TO: MUNICIPAL MANAGER 1983 July 20  
FROM: DIRECTOR PLANNING & BUILDING INSPECTION Our File: 08.126  
SUBJECT: CENTRAL AREA TRANSPORTATION PLANNING STUDY  
STAFF REVIEW REPORT

=====  
CENTRAL AREA TRANSPORTATION PLANNING STUDY  
=====

CORPORATION OF THE  
DISTRICT OF BURNABY  
1983 July 20

FIGURE 5

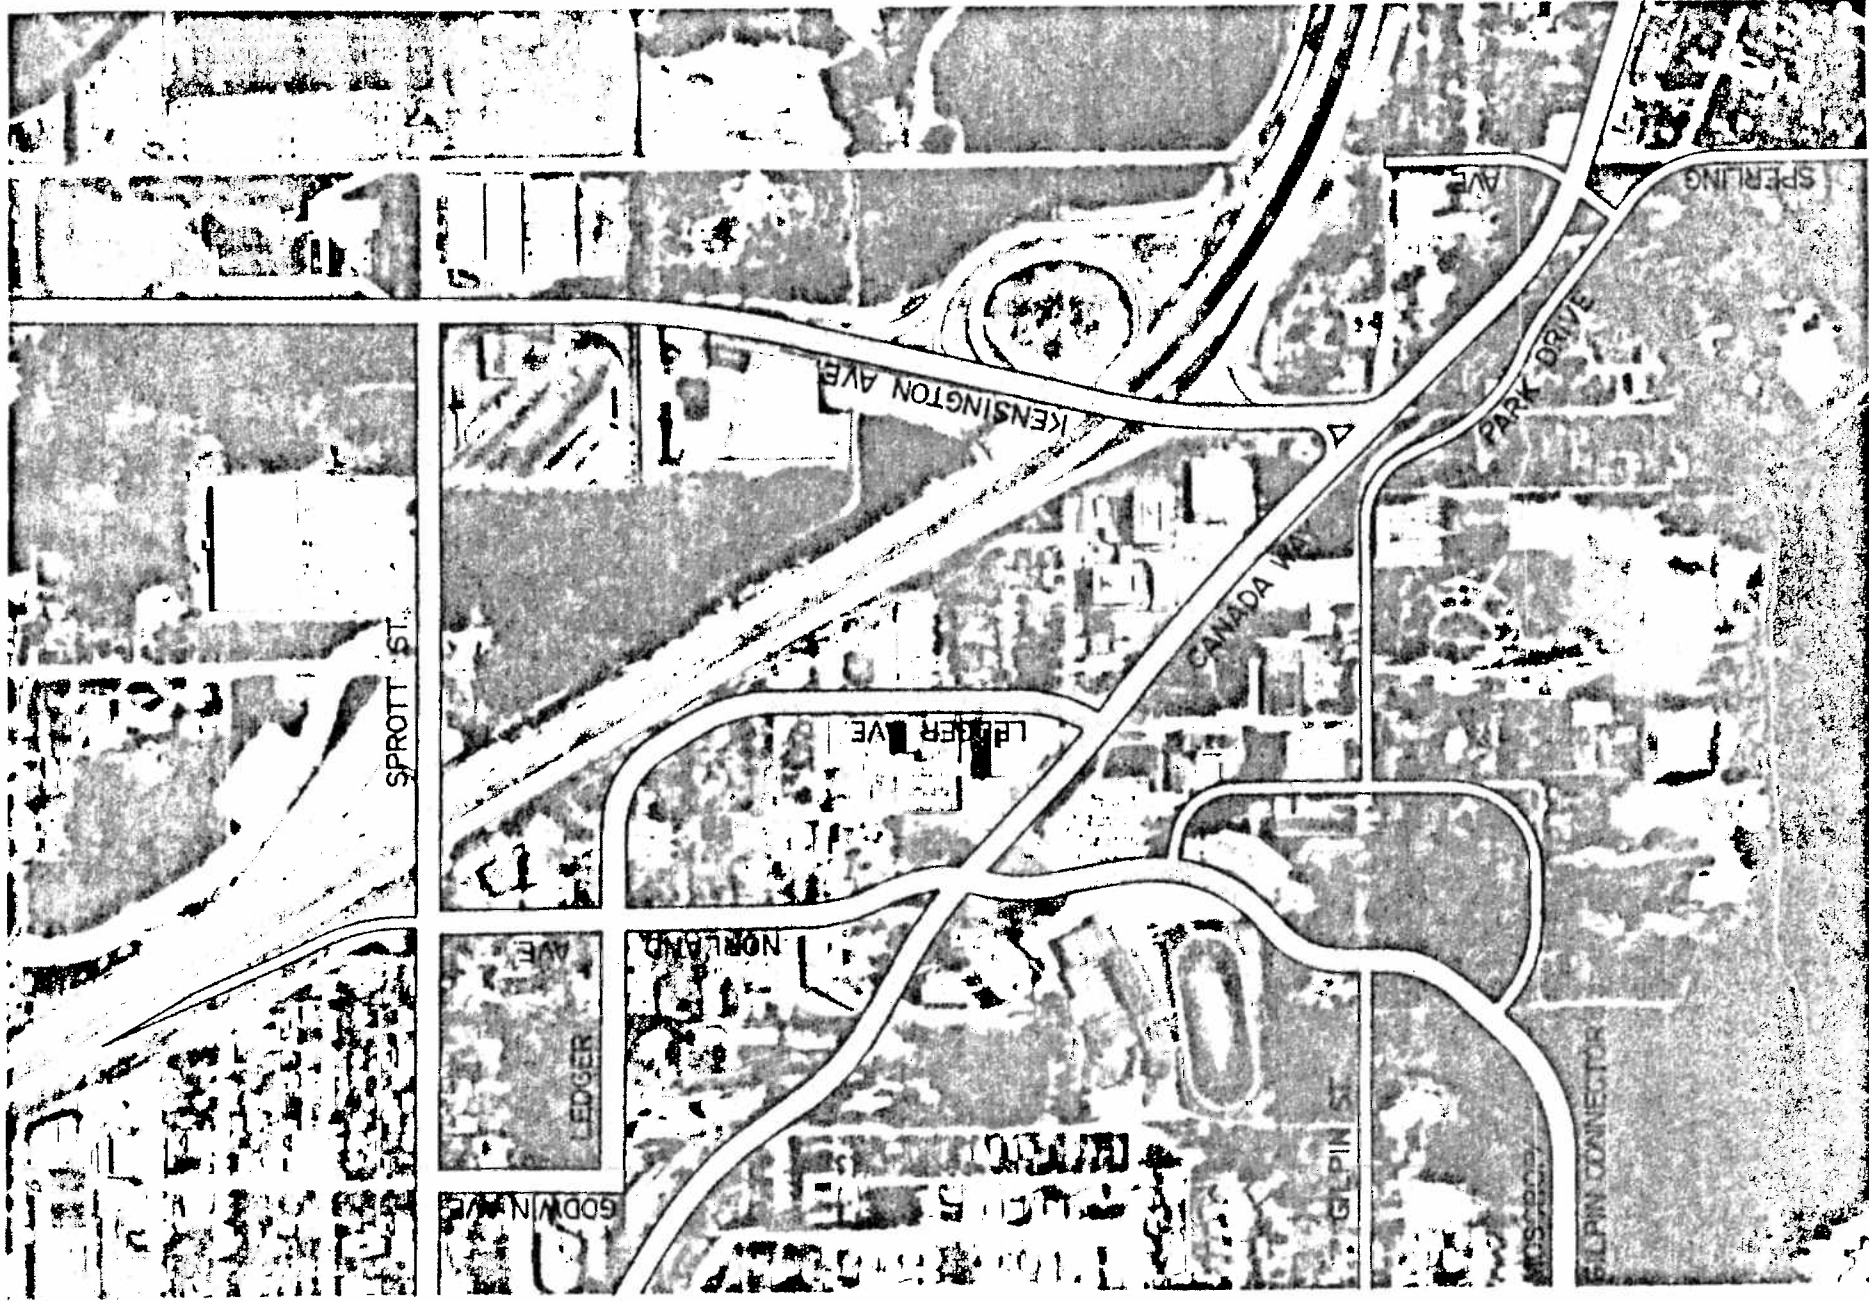
Staff agrees with the Consultant's objectives in preparing a plan for the area. The Consultant has recommended one approach to meeting the objectives. Staff has reviewed the implications of the Consultant's recommendations and are of the opinion that certain amendments would better address the objectives identified. This revised roadplan concept is illustrated in Figure 6.

The Park Drive proposed by staff (Figure 6) is considered to offer the following advantages over that recommended by the Consultant:

- The new vehicular access to the Municipal Courtyard proposed by the Consultant cannot be supported as it is considered too disruptive to the area. The route proposed by staff would not bring traffic to this pedestrian precinct.

Staff concurs with the concept of a gateway on the eastern side of the Century Park Area. However, the location of the Park Drive route together with its connection to the street network as recommended by the Consultant cannot be supported because of the advantages of the revised Park Drive route being recommended by staff. These advantages have been discussed in a previous section of this report.

The improvement recommended by the Consultant is not supported by staff because it would tend to perpetuate the flow of "through" traffic along Gilpin, a residential street.

FIGURE 6

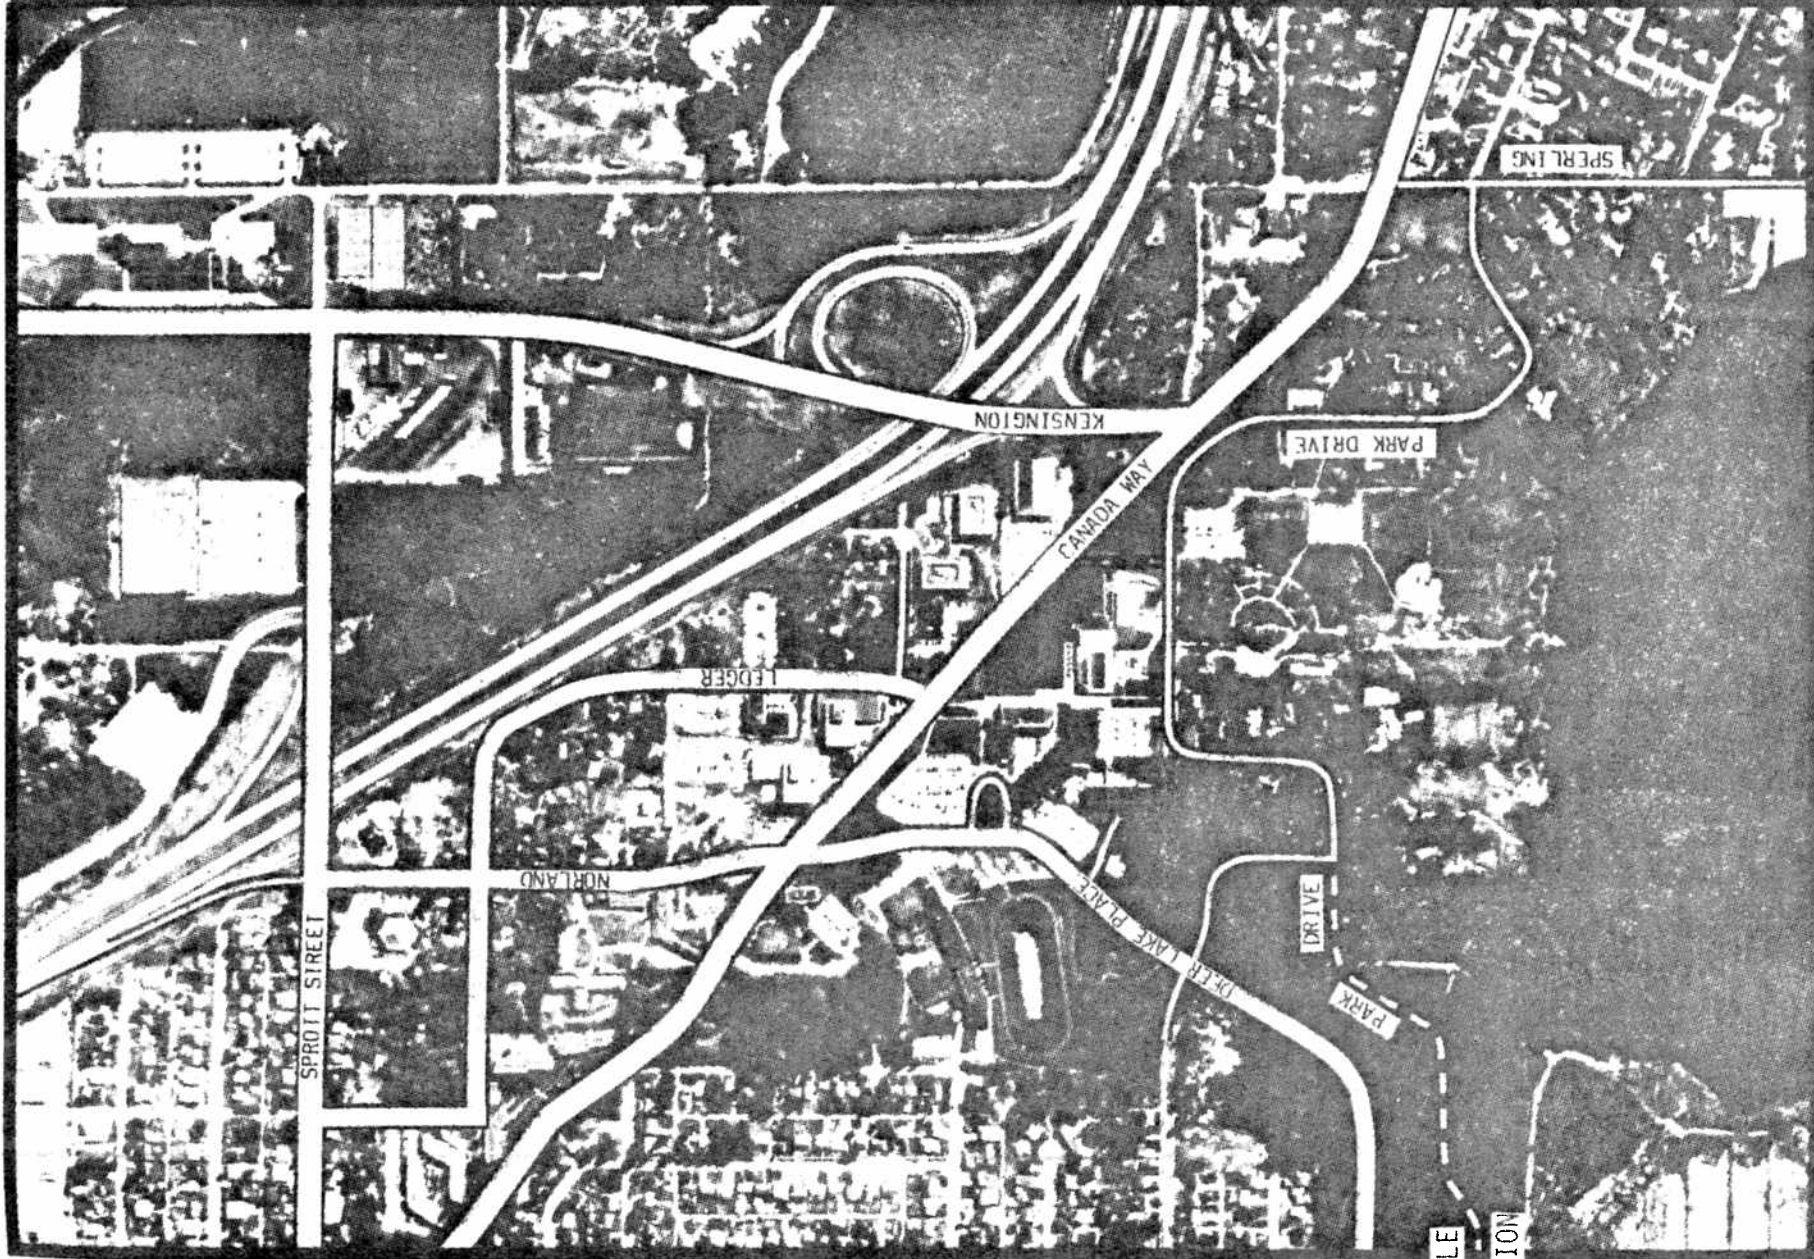
- The relocation of the Model Railway at Heritage Village Museum will not be necessary. Consequently there will be saving in costs in not having to rebuild and relocate the railway operation.

- The berm between Canada Way and Heritage Village Museum would not be lost. This ensures that the Museum is more divorced from the noise and urban nature of Canada Way.

- The route proposed by staff meanders through the Park. As a park drive this is more desirable because it provides for a better park experience, controls speeding and discourages its use by through traffic.

- The route can be staged over time in terms of both construction and location. Initially the Park Drive would utilize existing portions of both Deer Lake and Dale Avenues. Then, depending on the development plan for the Museum and the ultimate use of the Hart (Riley) property, the location of the Park Drive through the Hart property to Sperling Avenue may be adjusted to meet land use objectives for the area.

- (1) The road plan illustrated on Figure 6 is comprised of two inter-related parts; the external road network and the Park Drive. It is believed that careful coordination and timing of budgetting for the various design and construction elements can advance the over-all development thereby achieving the following:
  - The Municipal Administrative Complex will be thoroughly integrated with the Century Park area because all "through" traffic will be removed from between the two areas.
  - The Heritage Village Masterplan process can proceed with maximum flexibility.

FIGURE 7

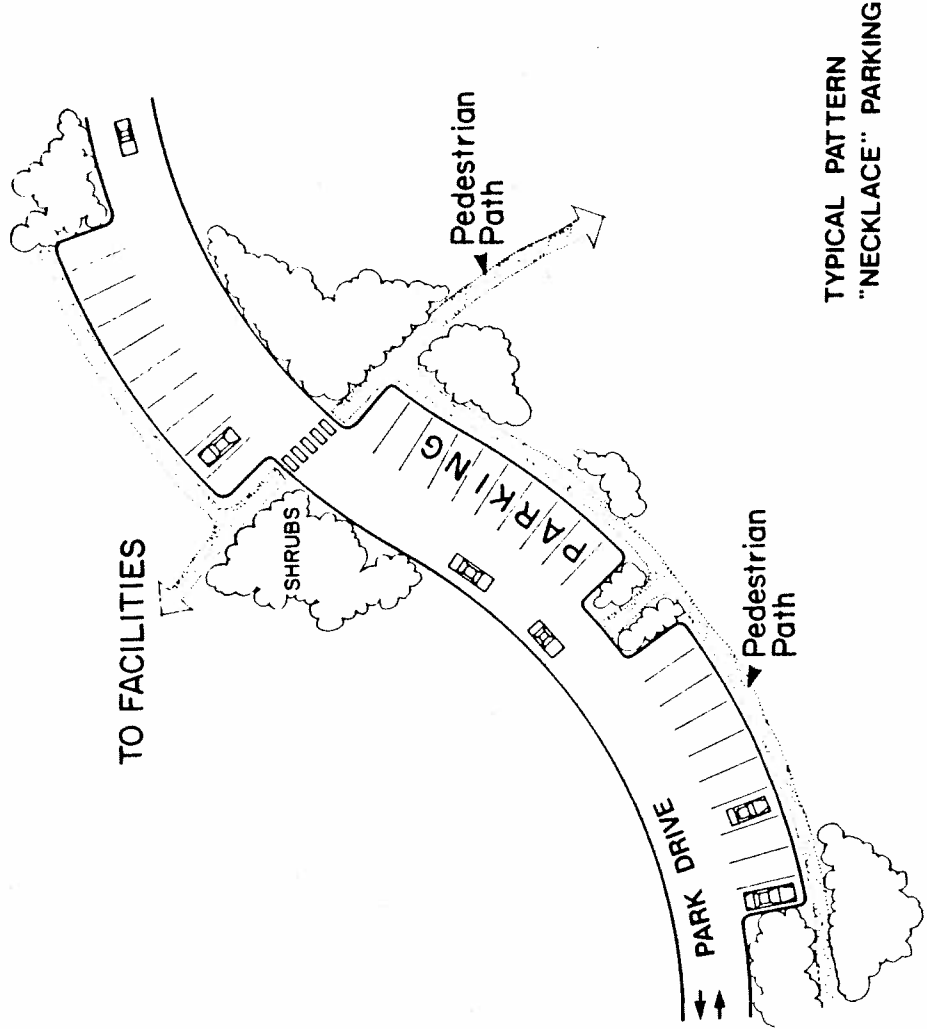
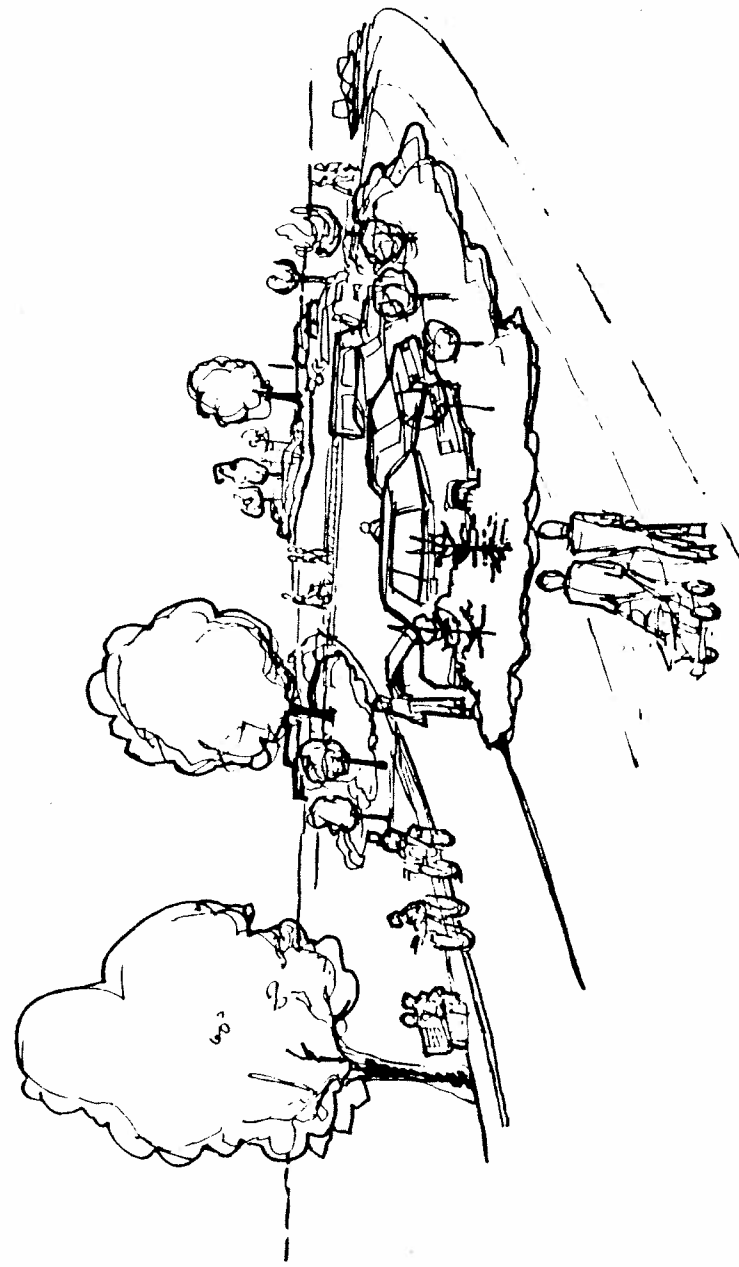
The Consultant has recommended the concept of "necklace" parking (see Figure 7) along the Park Drive as an effective and more sensitive means of providing additional parking rather than substantially enlarging or creating new parking lots with access roads into the Park area. The Consultant has recommended that the additional parking be provided in this manner because it is considered that this "necklace" parking together with the existing parking is adequate in terms of number and proximity to the facilities in the Century Park Area.

Staff concurs with the concept of "necklace" parking. Excluding the proposed new "necklace" parking there are currently approximately 850 public parking spaces within 10 minutes walking time of the Arts Centre Complex. Ten minutes walking time is considered about the maximum for park users. The "necklace" parking will provide for more parking closer to the various facilities than currently provide by virtue of the nature of the parking design. It will also easily meet the 87 additional parking spaces identified by the Consultant as being required.
